Objection numberOBJ27
Objector's Name Andrew Thompson
Date submitted..... 10 March 2015
NIMVO plot numberN/A

TransportNI has considered the correspondence in the above objection and responds as follows:

Client TRANSPORT NI	Project Title YORK STREET INTERCHANGE	Drawing Title YORK STREET INTERCHANGE PLAN REVISED NMU PROVISION PRE-INQUIRY	Designed EB	Drawn EB	Checked JM	Approved JM	Date 02/10/15	URS Infrastructure & Environment Ltd (EMI) Beech Hill House 40 Beech Hill Road Belfast Tel: +44 2890 705 111 Fax: +44 2890 705 651 www.ursgroup.com
			URS Internal Project No. 47037827		Suitability Fit for Information		URS	
			Scale @ A1 1:1250		Zone / Mileage Non-Motorised Users		Drawing Number TNI_YSI-JURS-ENM-ZZ-DR-HY-000007	
			THIS DOCUMENT HAS BEEN PREPARED PURSUANT TO AND SUBJECT TO THE TERMS OF URS' APPOINTMENT BY ITS CLIENT. URS ACCEPTS NO LIABILITY FOR ANY USE OF THIS DOCUMENT OTHER THAN BY ITS ORIGINAL CLIENT OR FOLLOWING URS' EXPRESS AGREEMENT TO SUCH USE, AND ONLY FOR THE PURPOSES FOR WHICH IT WAS PREPARED AND PROVIDED.				Rev P02

YORK STREET INTERCHANGE
TYPICAL SECTION
REVISED NMU PROVISION
PRE-INQUIRY

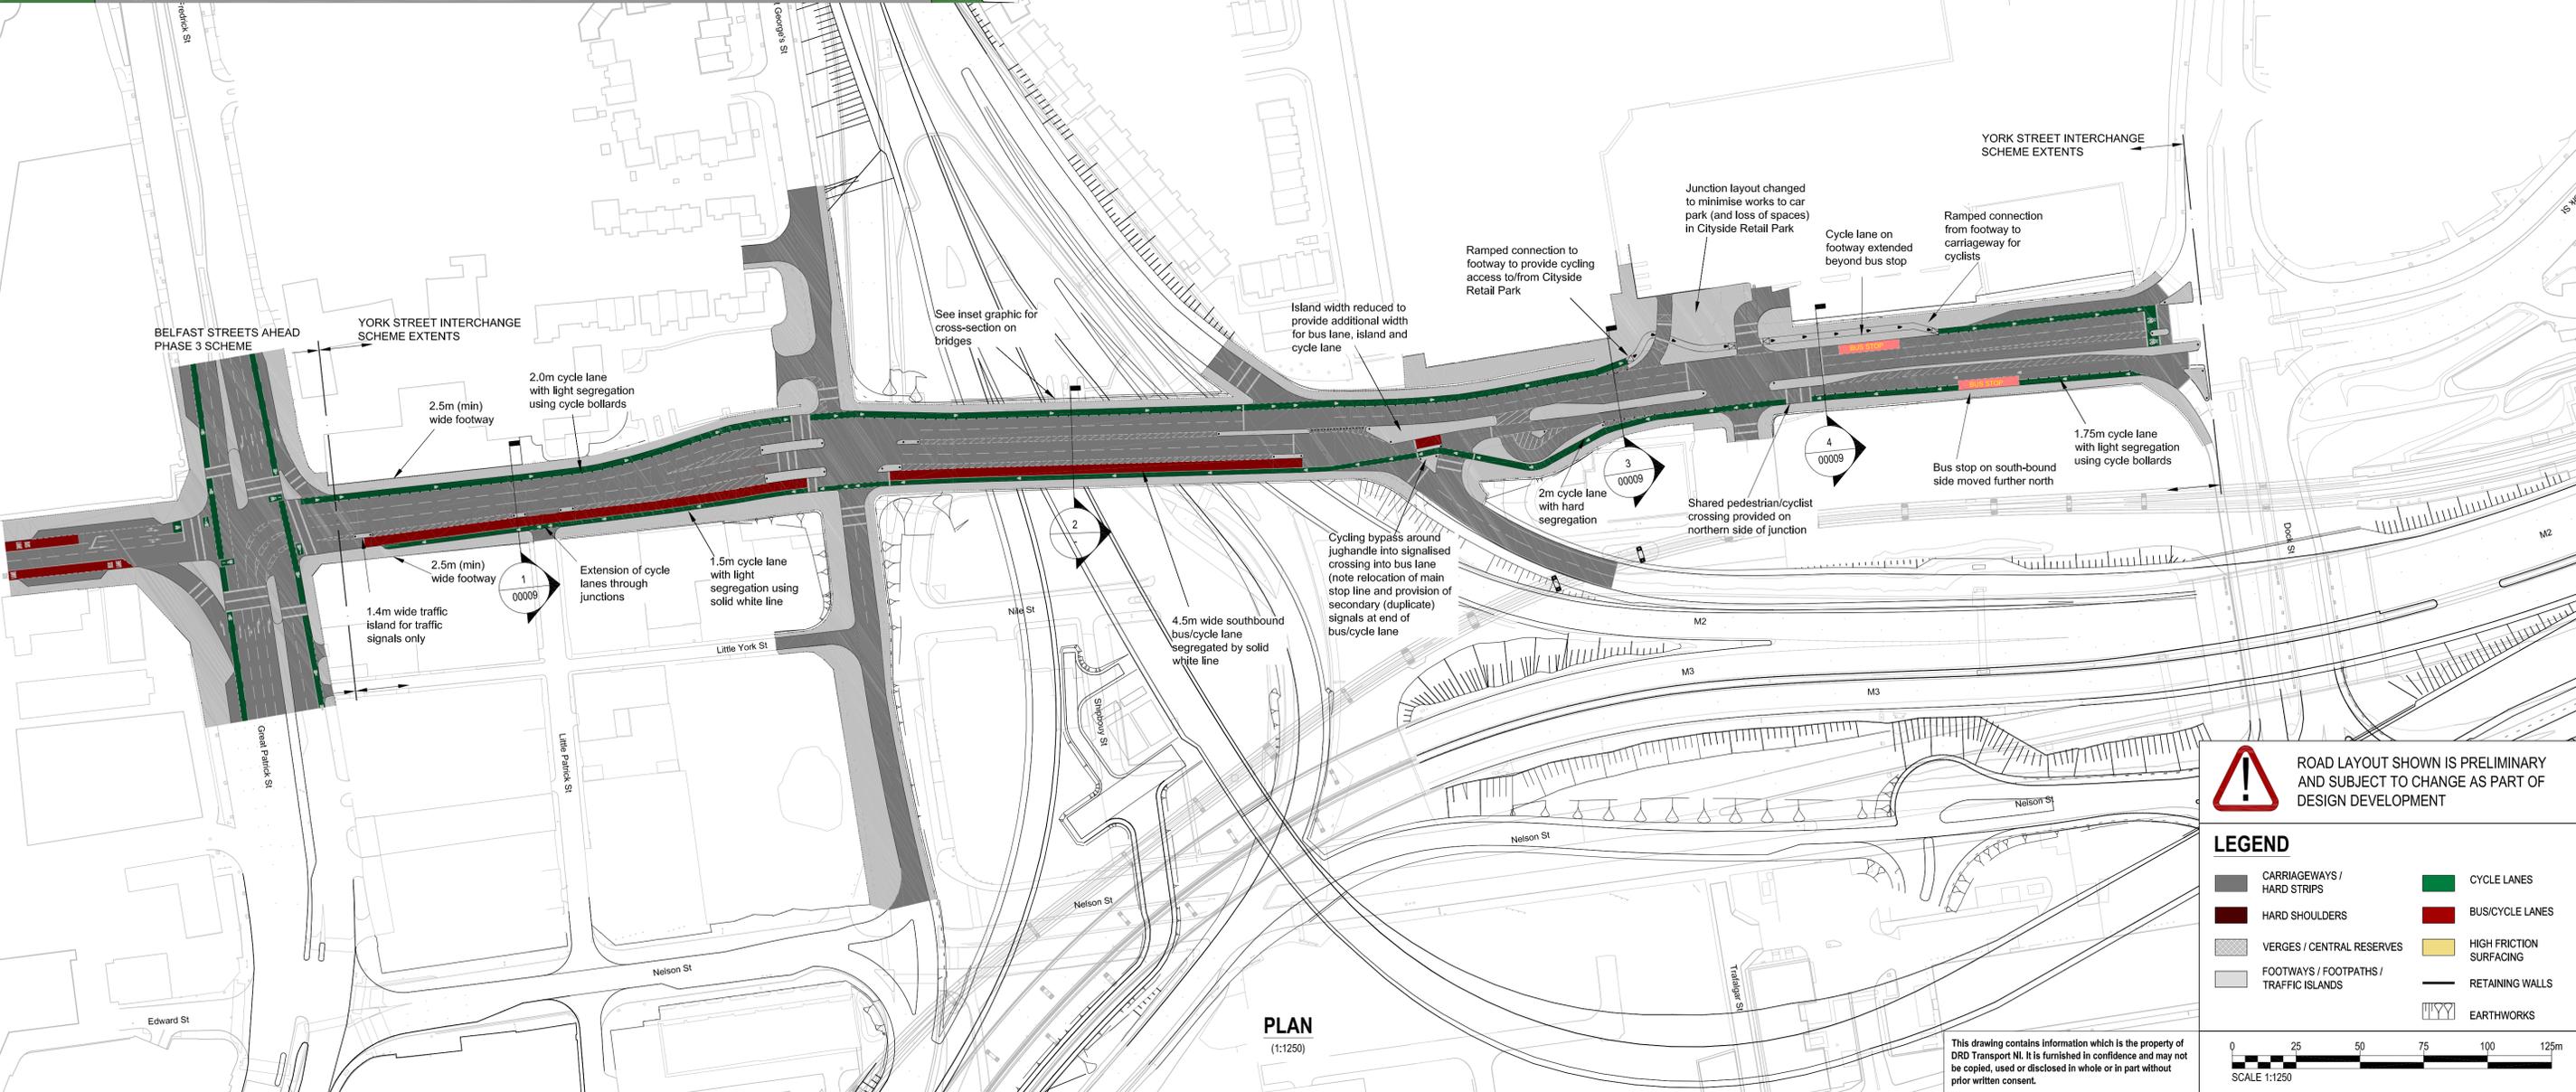
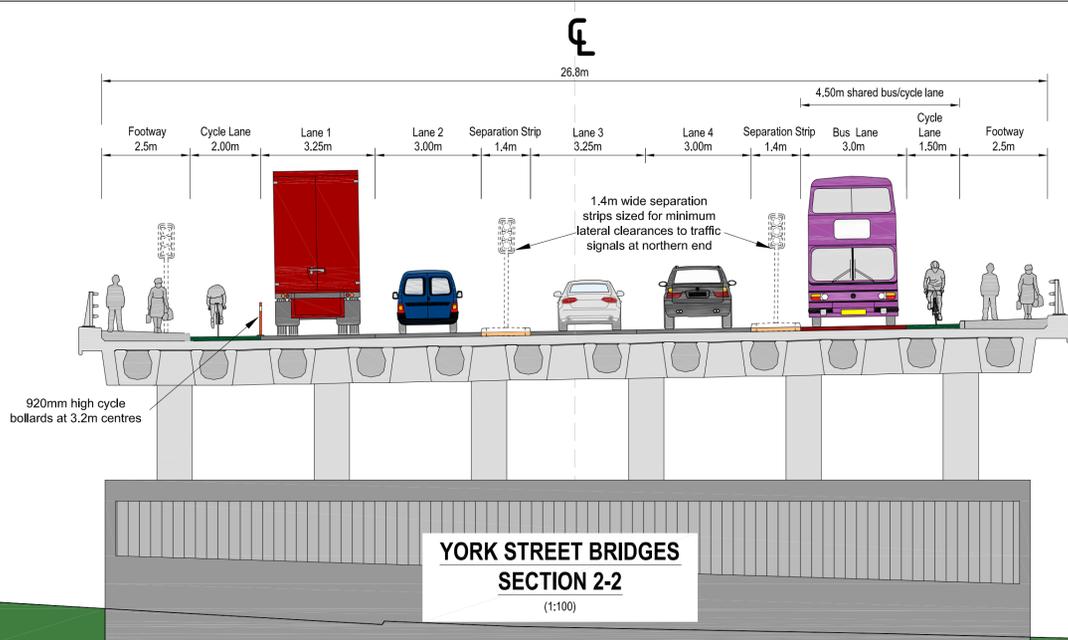
There should be wider pavements to facilitate the increase in footfall when the UU campus opens and rather than having to negotiate several junctions pedestrians should have a clear way between the train station and the campus.

How to do all this? Remove a car lane. Simple.

- b) Following the statutory consultation period, TransportNI has further engaged with Sustrans and DRD Cycling Unit to review provision for all non-motorised users on York Street. All aspects raised by your response have been considered in developing a revised proposal.
- c) We enclose two drawings illustrating the revised proposal for your information. The revised proposal will be available for discussion at the upcoming Public Inquiry.
